MORIN BUILDING
8570 EXECUTIVE PARK AVENUE
FAIRFAX, VIRGINIA 22116-0815

Subject: Addendum # 2 to IFB #18-53, Lee Highway Transmission Main

**IFB No. 18-53
PROJECT 2545, DIVISION 2
LEE HIGHWAY TRANSMISSION MAIN**

PROJECT	DIVISION	JUNE 2018
2545	2	SHEET 13
TAX MAP	49-2, 49-4	Of 54

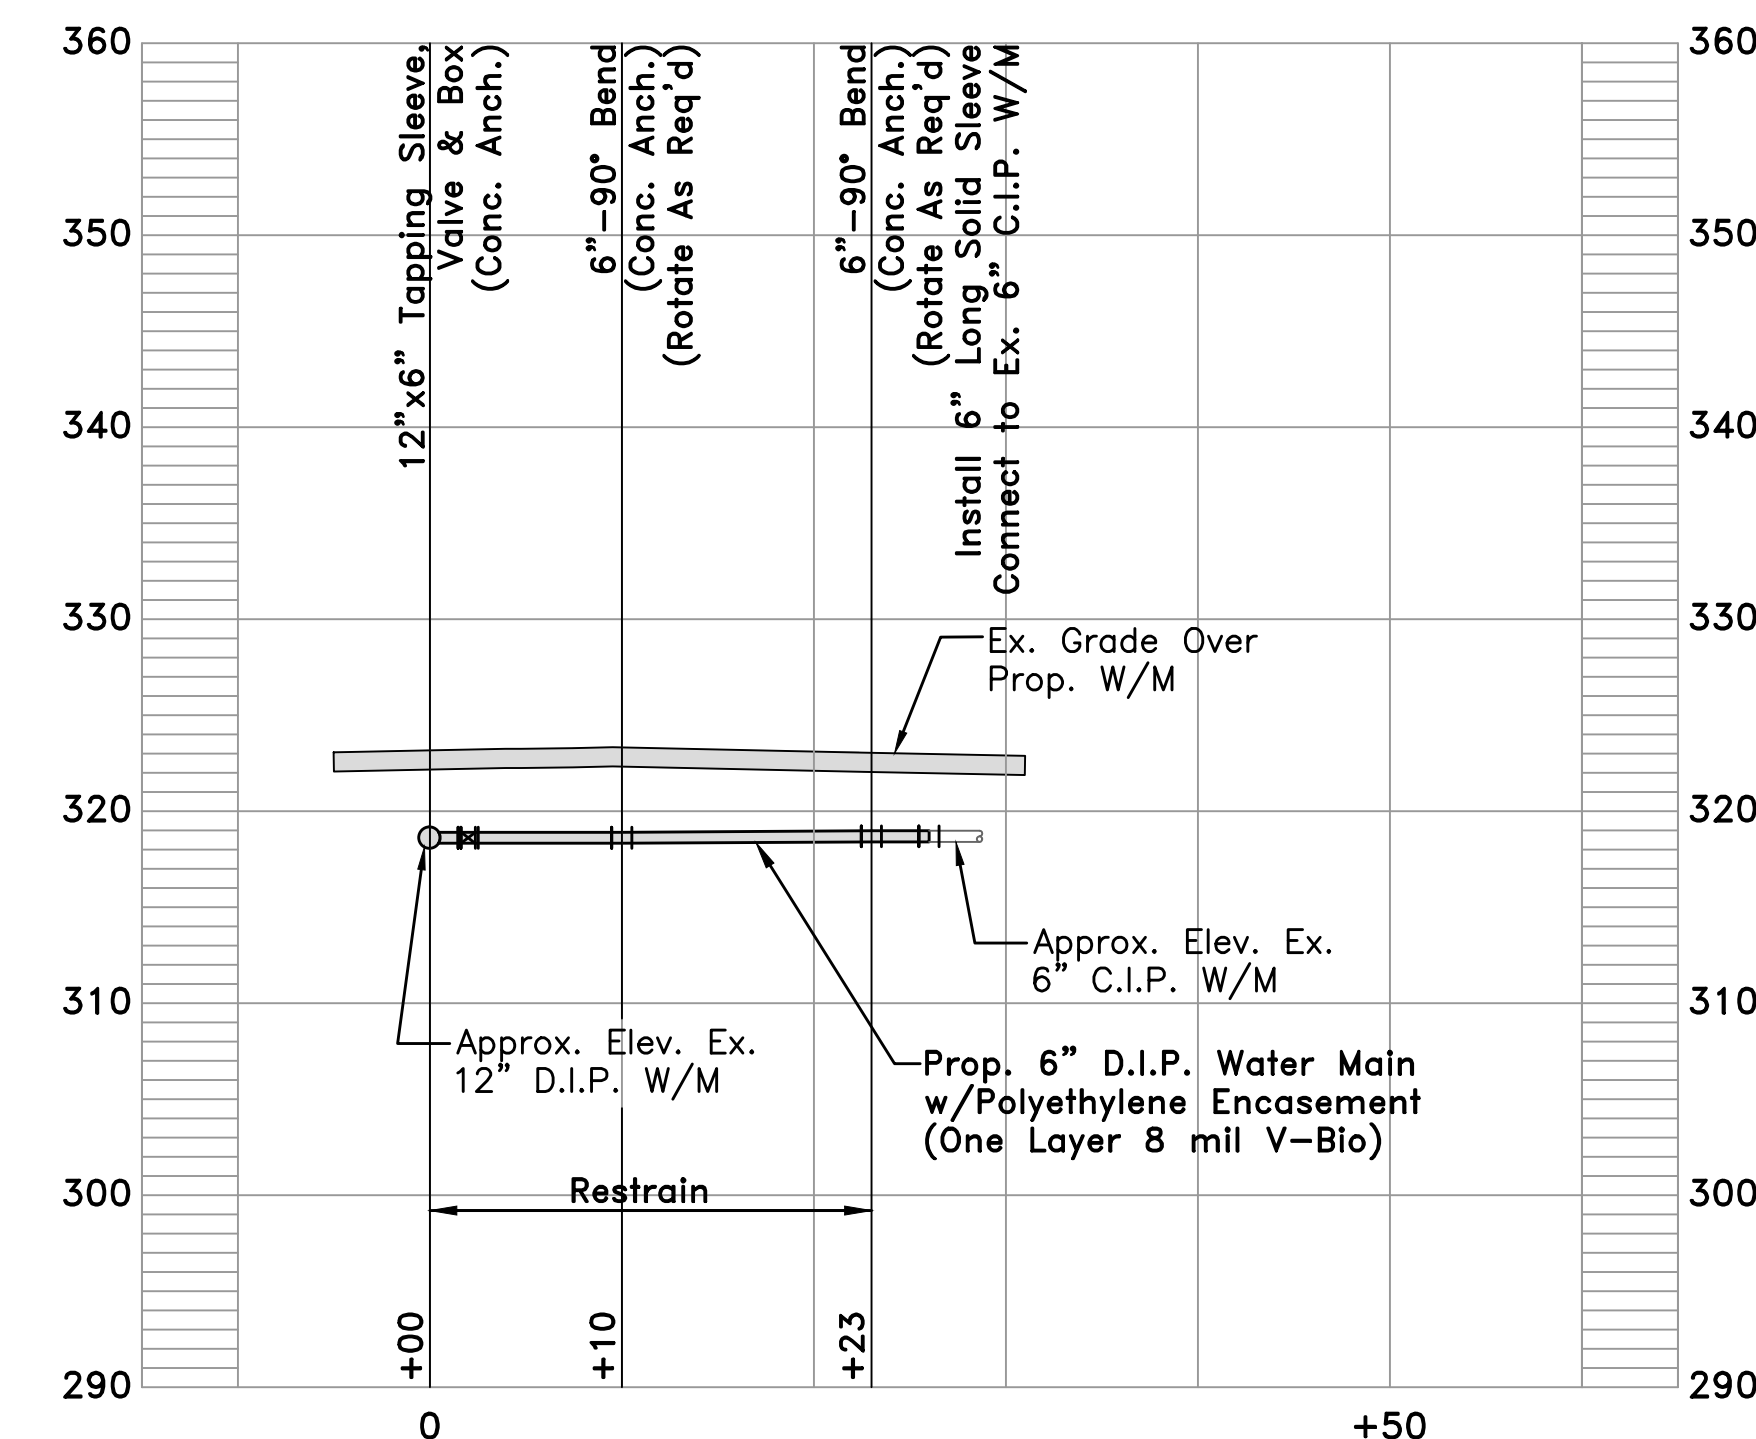
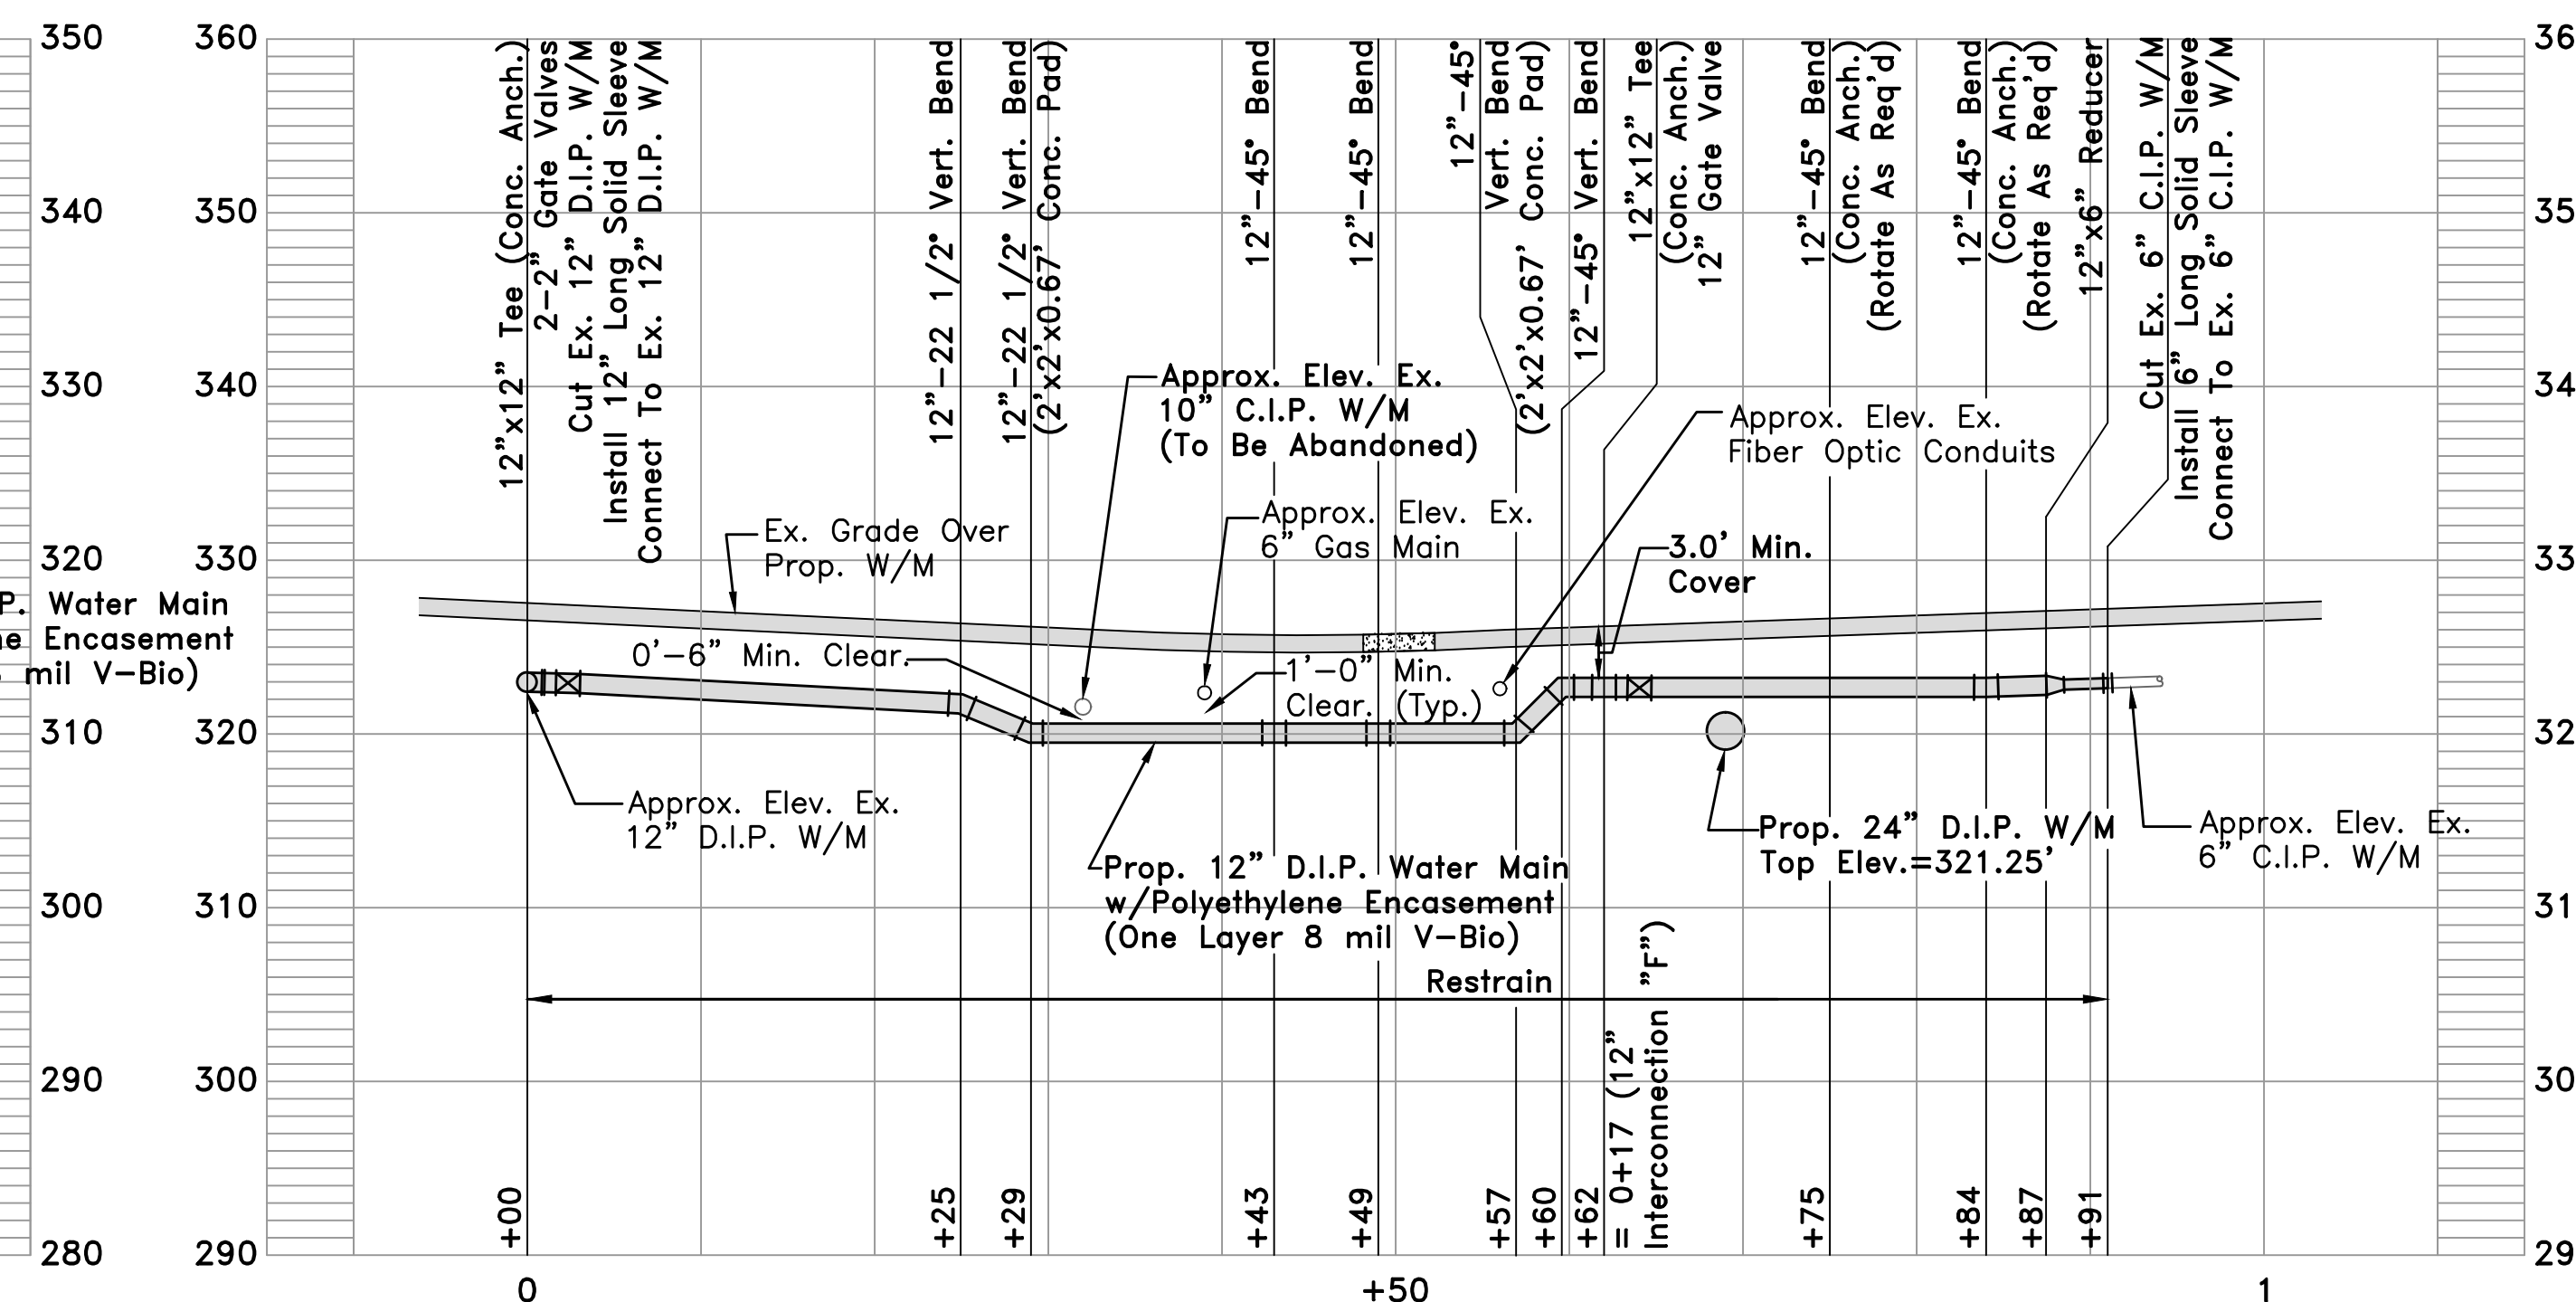
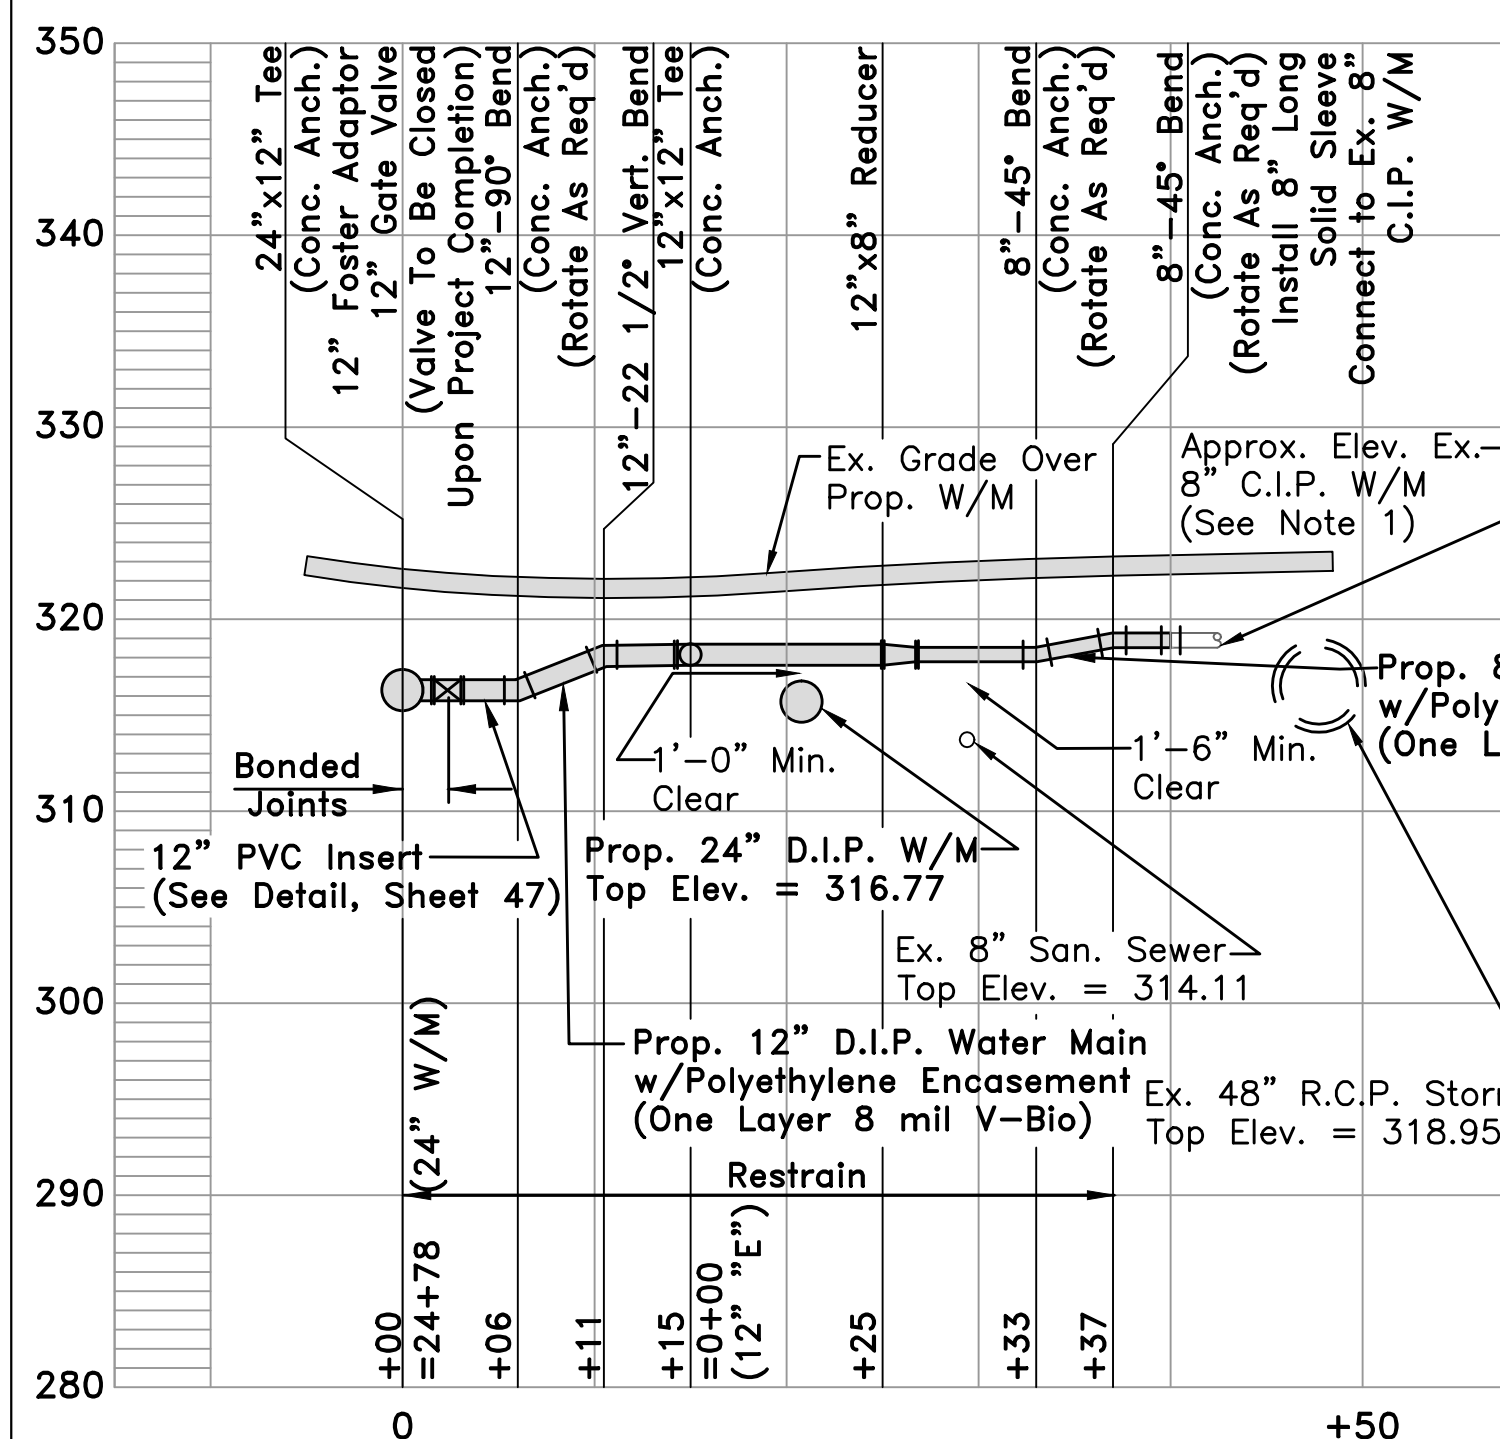
A. *Limits of proposed pavement restoration on private properties is required as indicated in the Contract Documents.*
2. Drawing 13 has two interconnections that are both labeled as Interconnection "E". Profile Drawing on Sheet 30 has the 12" Interconnection "E" at 117 LF and Sheet 30A has it at 17 LF. Which is correct?

DESIGNED:	PA	6/27/18	Addendum No. 2 – Revised Name Of 12" Interconnection "E" To "F".
DRAWN:	MAR/SRB		Added Note 7 – Access To Fairfield Crossing LLC Property.
CHECKED:	RSQ		
NO.	DATE

A. *This matter is addressed in this Addendum.*
